East Venice Community Plan Proposed VNC Recommendations

August 2026

Presentation by the VNC's Community Plan/Local Coastal Program
Ad Hoc Committee

1. Single-Family Residences (Low Residential)

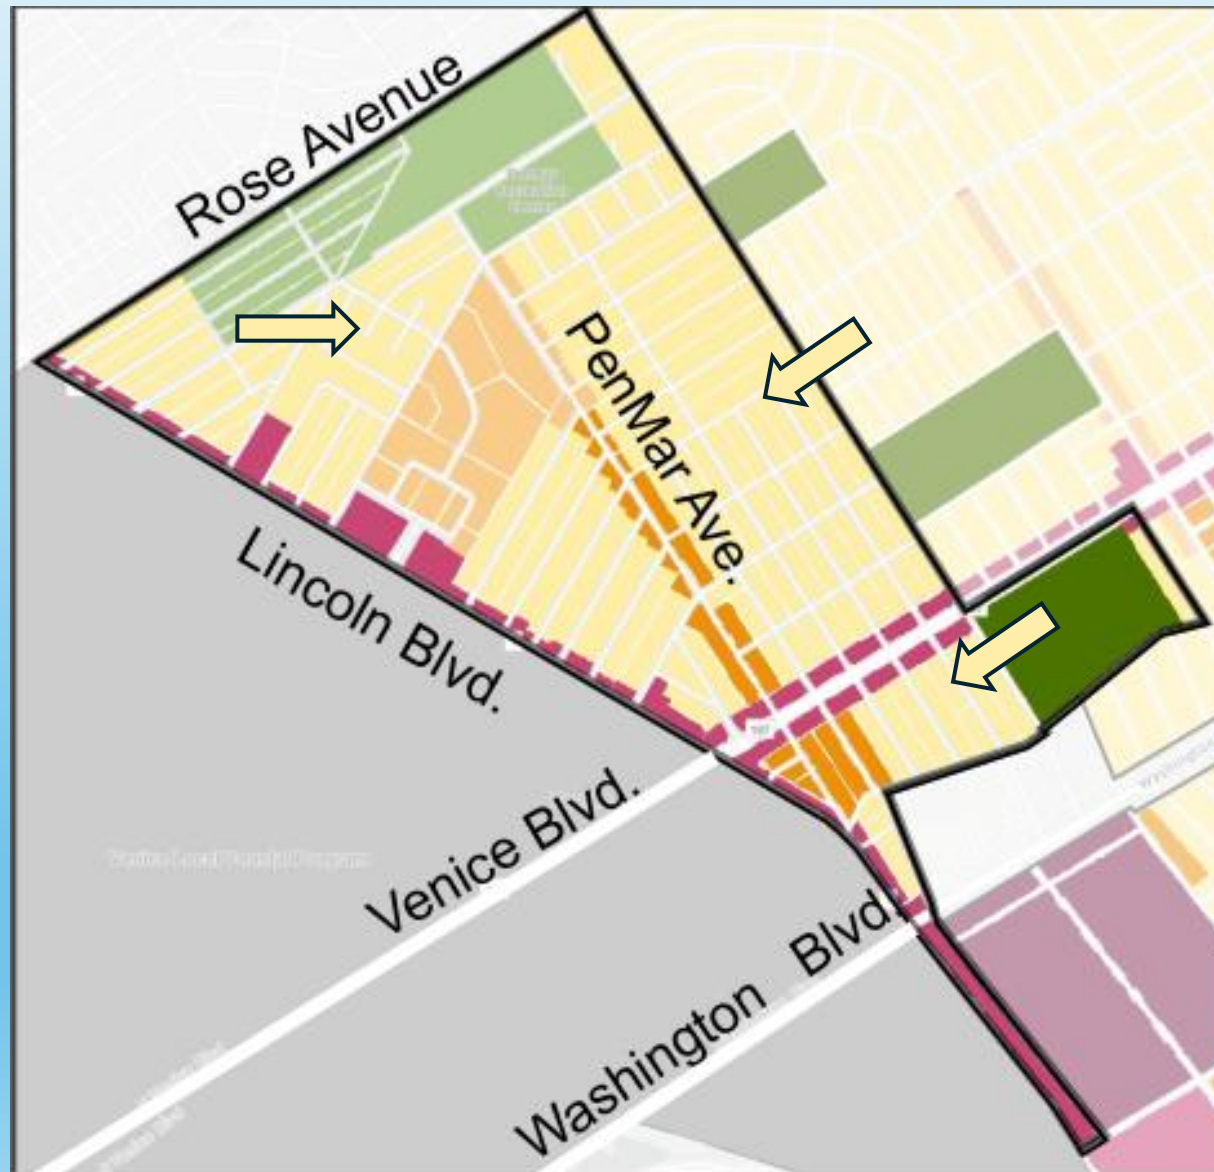
Comparison of VNC 2024, City Planning 2026, and VNC 2026	Density - DU/lot (excluding ADUs)	Maximum Height: Tier 1 Bonus Tier 2 Bonus	Floor Area Ratio (FAR): Tier 1 Bonus Tier 2 Bonus
VNC Recommendation (2024)	1 DU/lot	2 stories, ≤30' no bonuses	0.45 - 0.55 no bonuses
City Planning Proposed (2026)	1 DU/lot	33' no bonuses	0.45 - 0.57 no bonuses
Revised VNC Recommendation (2026)	1 DU/lot	2 stories, ≤30' no bonuses	0.45 – 0.55 no bonus

Change from 2024 VNC Recommendation – no change

2. Lincoln Place (Low Medium Residential)

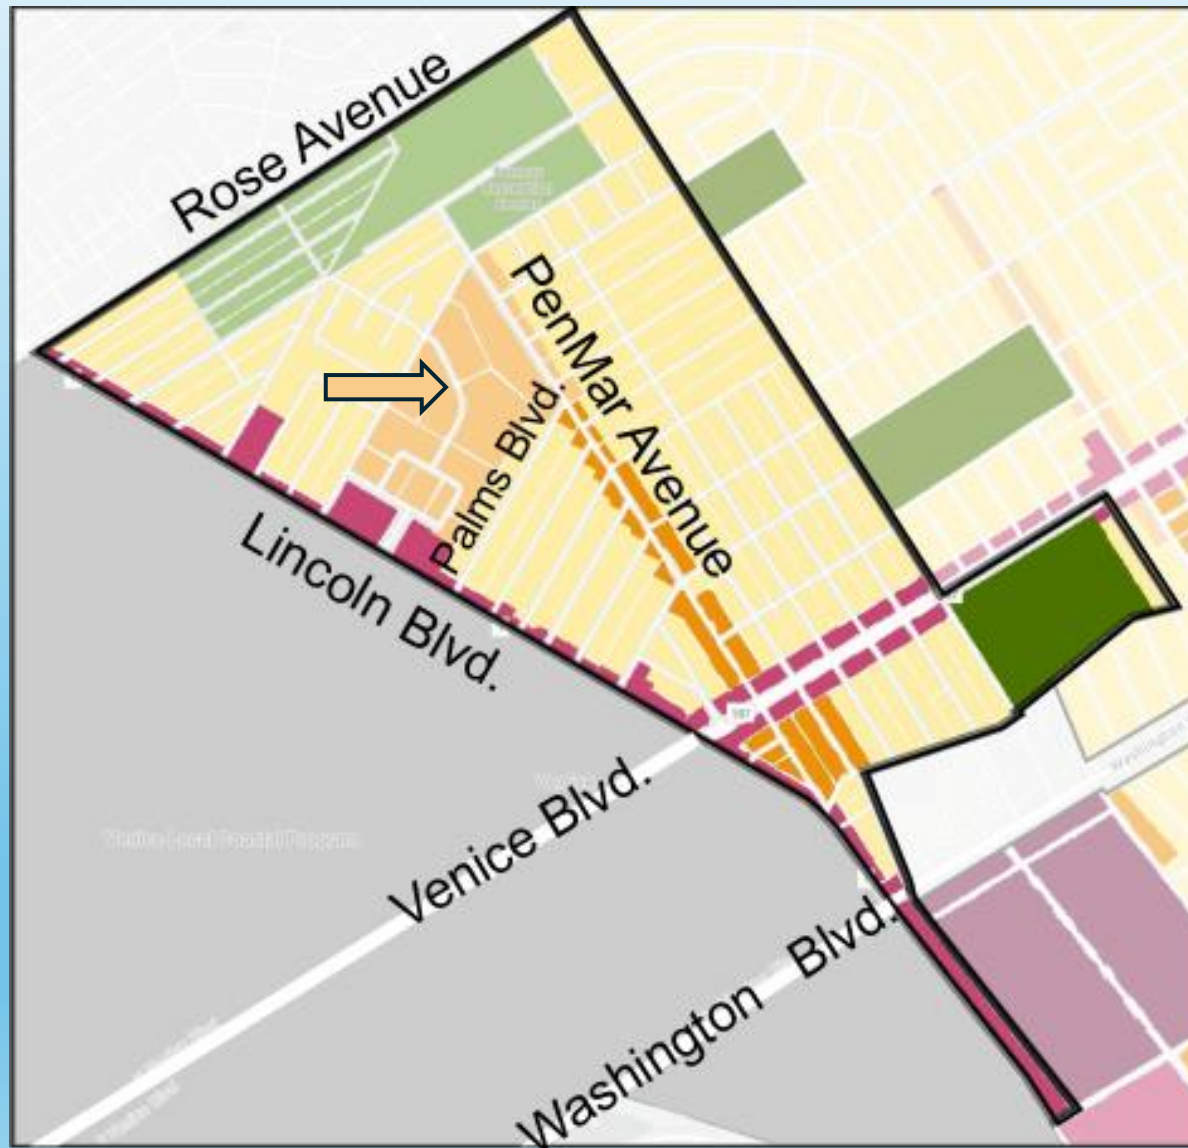
Comparison of VNC 2024, City Planning 2026, and VNC 2026	Density - DU/Lot (excluding ADUs)	Maximum Height: Tier 1 Bonus Tier 2 Bonus	Floor Area Ratio (FAR): Tier 1 Bonus Tier 2 Bonus
VNC Recommendation (2024)	1 DU/1,500 SF of lot	2 stories, ≤25' no bonuses	0.9 (1.0 with bonus)
City Planning Proposed (2026)	1 DU/1,500 SF of lot	3 stories (Tier 1 bonus = 4)	1.5 (Tier 1 bonus = 2.0)
Revised VNC Recommendations (2026)	1 DU/1,500 SF of lot	2 stories, ≤25' (no bonuses)	0.9 (no bonuses)

Change from 2024 VNC Recommendation – no change

3. Penmar Ave Adjacent to Lincoln Place (Low Medium Residential)

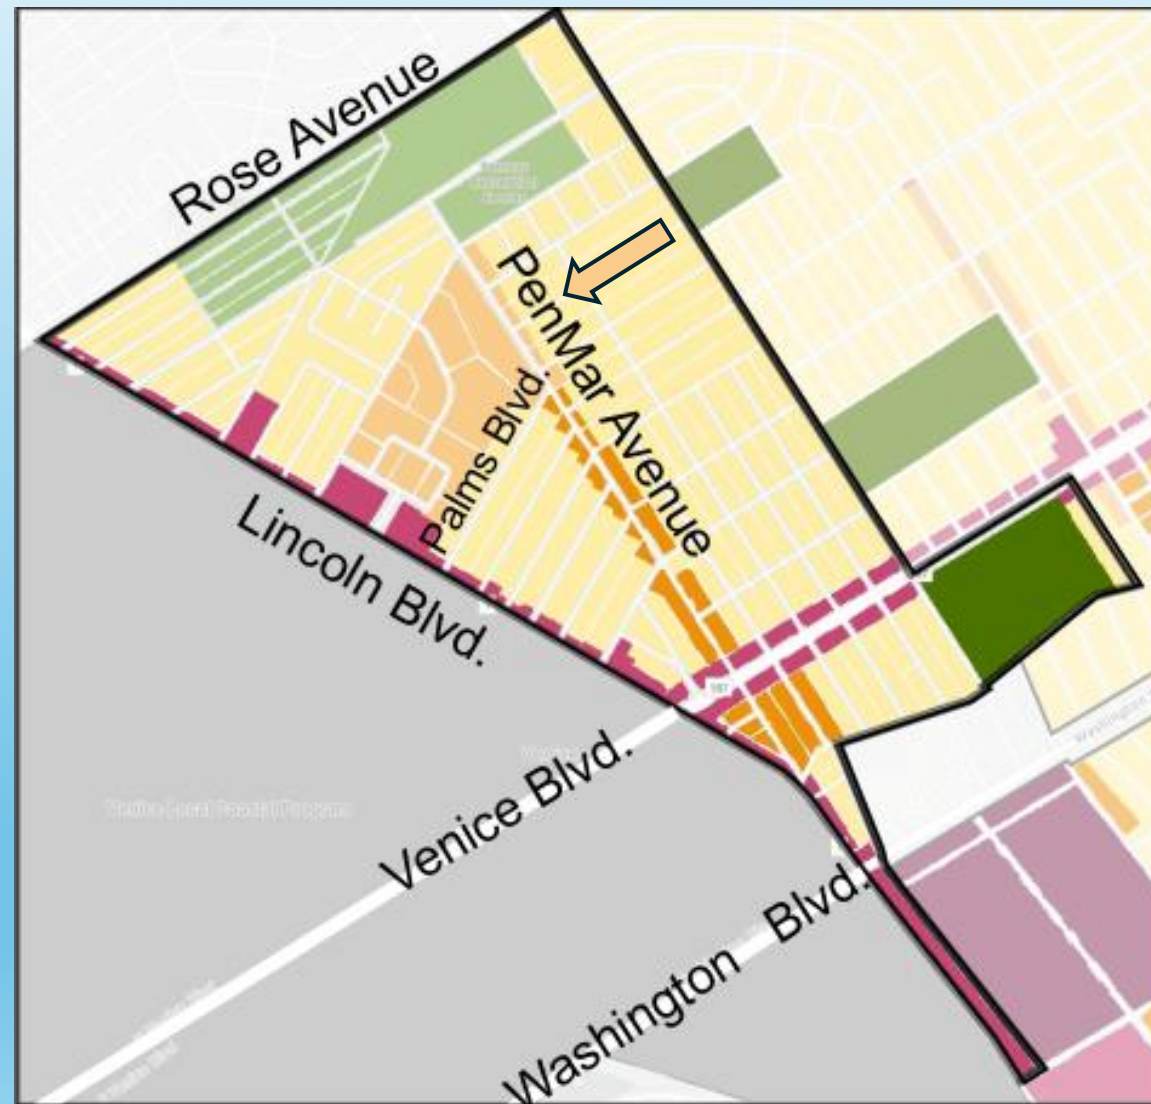
Comparison of VNC 2024, City Planning 2026, and VNC 2026	Density - DU/Lot (excluding ADUs)	Maximum Height: Tier 1 Bonus Tier 2 Bonus	Floor Area Ratio (FAR): Tier 1 Bonus Tier 2 Bonus
VNC Recommendation (2024)	1 DU/1,500-3,000 SF of lot	2 stories, ≤25' (no bonuses)	0.9 (1.0 with bonus)
City Planning Proposed (2026)	1 DU/2,000 SF of lot	3 stories (no bonuses)	1.0 (Tier 1 bonus = 1.5)
Revised VNC Recommendations (2026)	1 DU/2,000 SF of lot	2 stories, ≤25' (no bonuses)	0.9 (Tier 1 bonus = 1.0)

Change from VNC 2024 Recommendation – no change

4. Penmar Avenue South of Palms Avenue (Medium Residential)

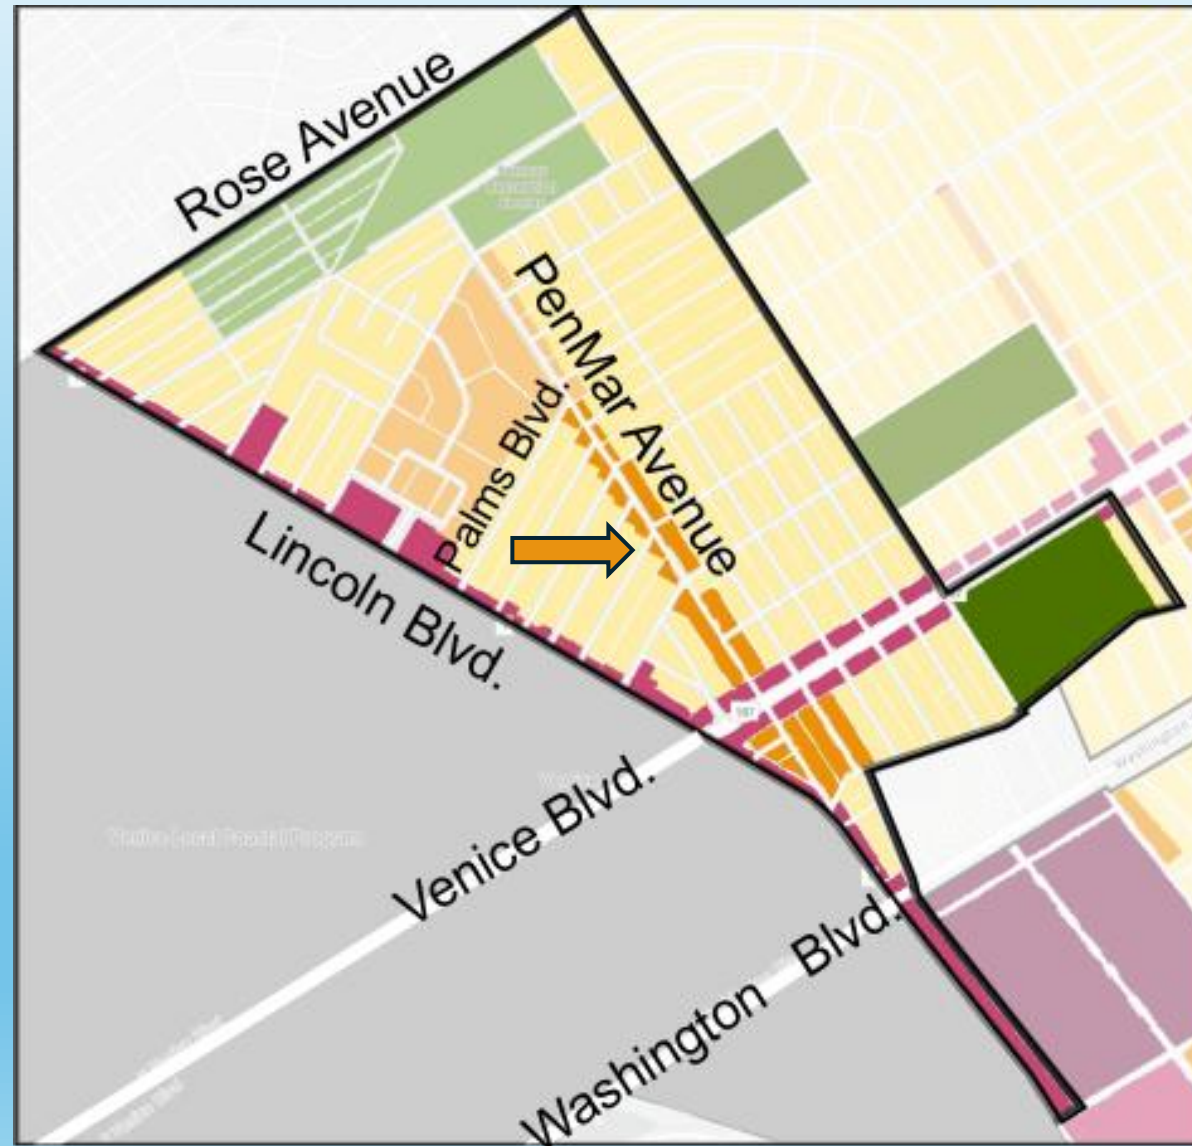
Comparison of VNC 2024, City Planning 2026, and VNC 2026	Density - DU/lot (excluding ADUs)	Maximum Height: Tier 1 Bonus Tier 2 Bonus	Floor Area Ratio (FAR): Tier 1 Bonus Tier 2 Bonus
VNC Recommendation (2024)	1 DU/1,500 SF of lot and 2 DU/lot	2 stories, ≤25' no bonuses	0.75 (1.0 bonus)
City Planning Proposed (2026)	1 DU/1,000 SF of lot, 1DU/3,000 SF of lot in places	3 stories (Tier 1 bonus = 7) (Tier 2 bonus = 8)	1.5 (Tier 1 bonus = 4.5) (Tier 2 bonus = 5.0)
 Revised VNC Recommendation (2026)	1 DU/1,500 SF of lot	2 stories, ≤25' (Tier 1 bonus = 3, ≤33') (no Tier 2 bonus)	0.75 (Tier 1 bonus = 1.5) (no Tier 2 bonus)

Change from VNC 2024 Recommendation - increased height to 3 stories

5. Neighborhood South of Venice Blvd and North of Washington Blvd (**Varies**)

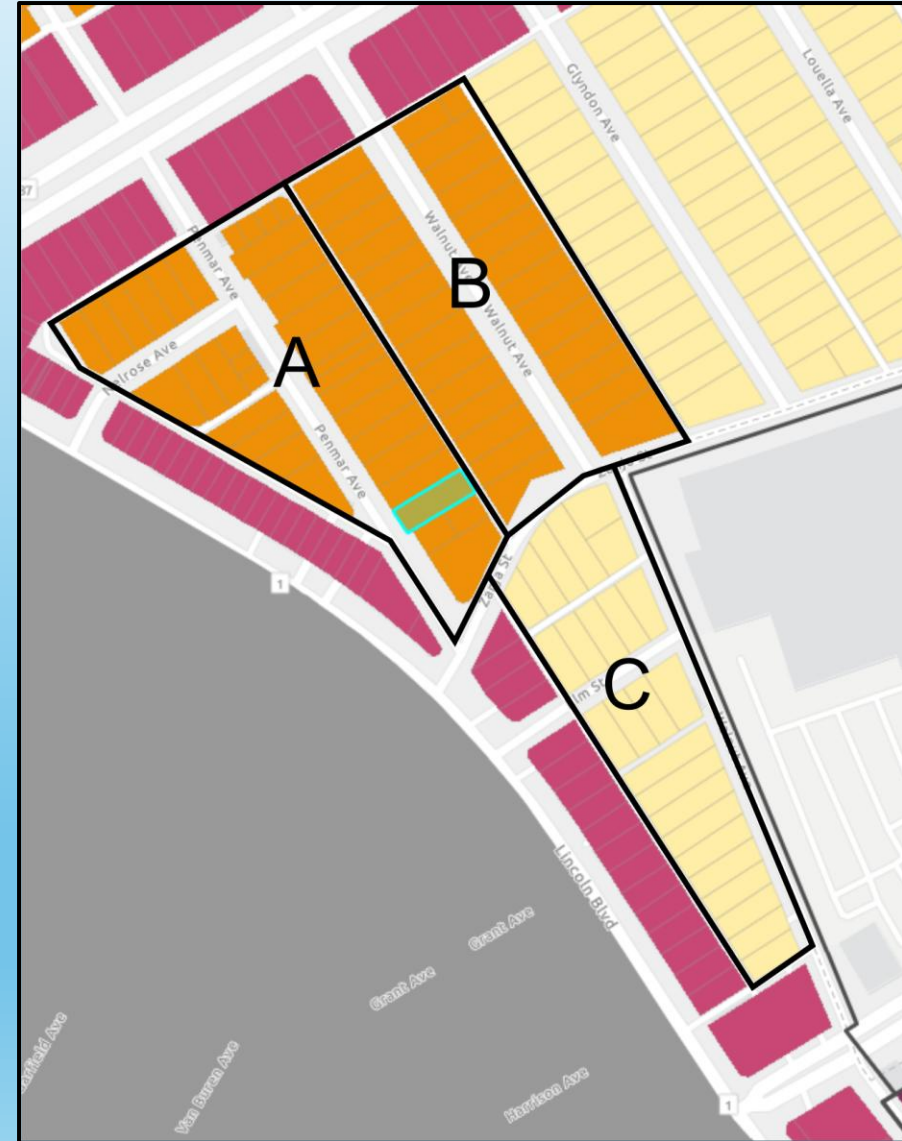
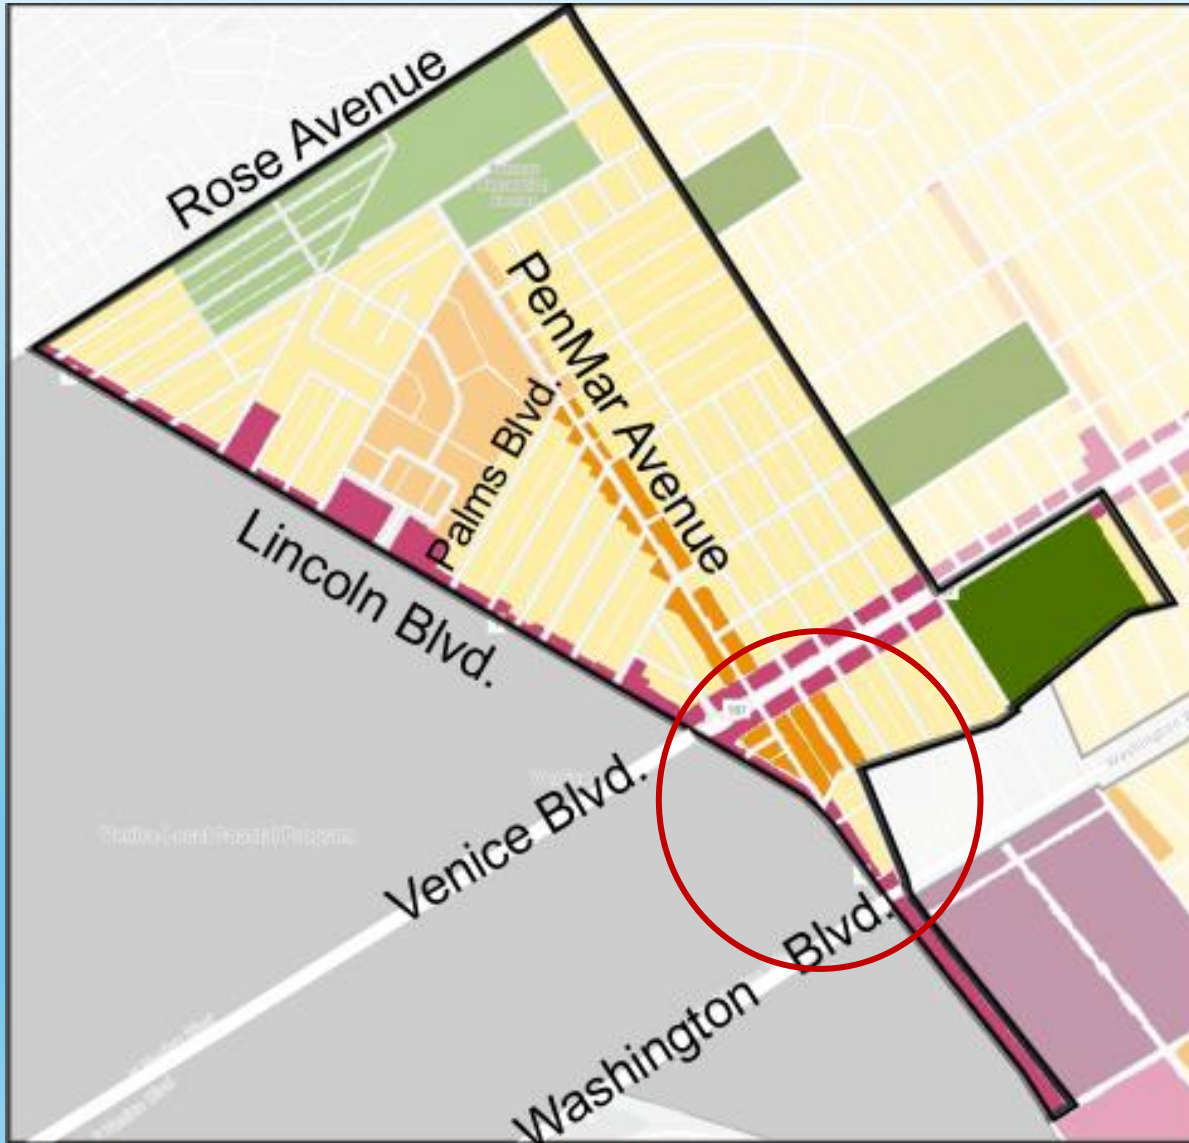
Comparison of VNC 2024, City Planning 2026, and VNC 2026	Density - DU/Lot (excluding ADUs)	Maximum Height: Tier 1 Bonus Tier 2 Bonus	Floor Area Ratio (FAR): Tier 1 Bonus Tier 2 Bonus
VNC Recommendation (2024)	1 DU/1,500 SF of lot 2 DU/lot (Walnut)	2 stories, ≤25' no bonuses	0.75 (1.0 bonus, exc. Walnut)
City Planning Proposed (2026)	1 DU/1,000 SF of lot	3 stories (Tier 1 bonus = 7) (Tier 2 bonus = 8)	1.5 (Tier 1 bonus = 4.5) (Tier 2 bonus = 5.0)

A. Penmar Avenue and Nelrose Avenue north of Zanja Street (Low Medium Residential)			
VNC Recommendations (2026)	1 DU/1,000 SF of lot	2 stories, ≤25' (Tier 1 bonus = 3, ≤33') (no Tier 2 bonus)	0.75 (Tier 1 bonus = 1.5) (no Tier 2 bonus)

B. Walnut Avenue north of Zanja Street (Low Residential)			
VNC Recommendations (2026)	1 DU/1,500 SF of lot	2 stories, ≤30' (no bonuses)	0.75 (no bonuses)

C. Walnut Avenue and Elm Street South of Zanja Street (Medium Residential)			
VNC Recommendations (2026)	1 DU/1,000 SF of lot	3 stories, ≤33' (Tier 1 = 6 stories) (Tier 2 = 7 stories)	1.5 (Tier 1 bonus = 3.5) (Tier 2 bonus = 4.0)

6. Lincoln Blvd from Rose Ave to Washington Blvd (Community Center)

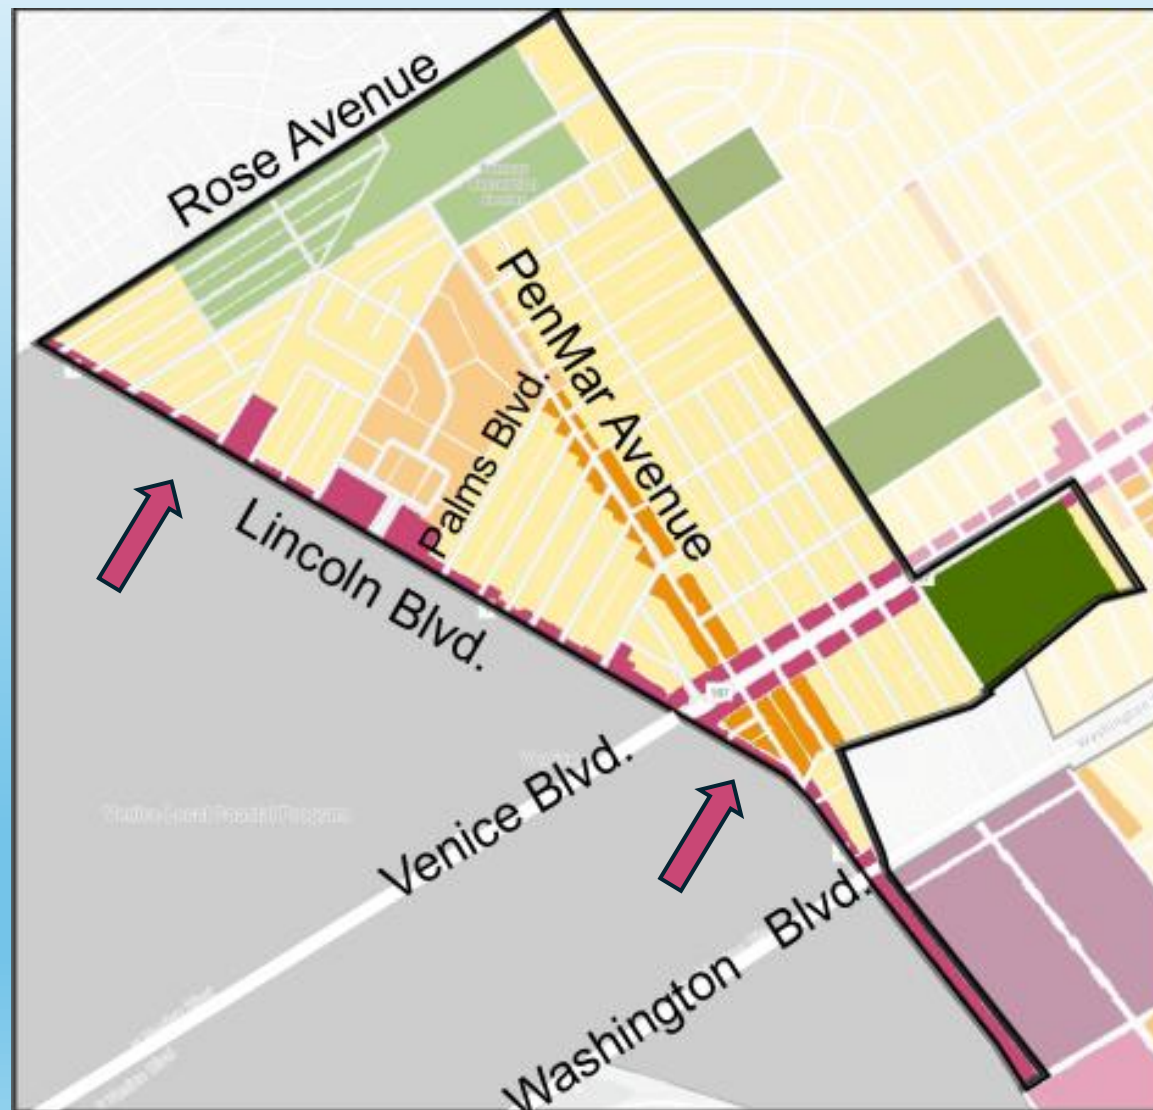
Comparison of VNC 2024, City Planning 2026, and VNC 2026	Density - DU/Lot (excluding ADUs)	Maximum Height: Tier 1 Bonus Tier 2 Bonus	Floor Area Ratio (FAR): Tier 1 Bonus Tier 2 Bonus
VNC Recommendation (2024)	800SF/DU	3 stories, ≤33' (5 stories, ≤55' with bonus)	1.25 (2.0 with bonus)
City Planning Proposed (2026)	1 DU/400 SF of lot	3 stories (Tier 1 bonus = 7 or 8) (Tier 2 bonus = 8 or 10)	1.5 (Tier 1 bonus: 4.5 or 5.0) (Tier 2 bonus: 5.0 or 5.5)
 VNC Recommendations (2026) for lots ≤20,000SF	1 DU/400 SF of lot	3 stories, ≤33' (Tier 1 bonus = 6 stories, ≤66') (Tier 2 bonus = 7 stories, ≤77')	2.5 (Tier 1 bonus = 3.5) (Tier 2 bonus = 4.0)
 VNC Recommendations (2026) for lots ≥20,000SF	1 DU/400 SF of lot	3 stories, ≤33' (Tier 1 bonus = 7 stories, ≤77') (Tier 2 bonus = 8 stories, ≤88')	2.0 (Tier 1 bonus = 4.0) (Tier 2 bonus = 4.5)

Change from VNC 2024 Recommendation – added height, 2-step bonus, and FAR increase
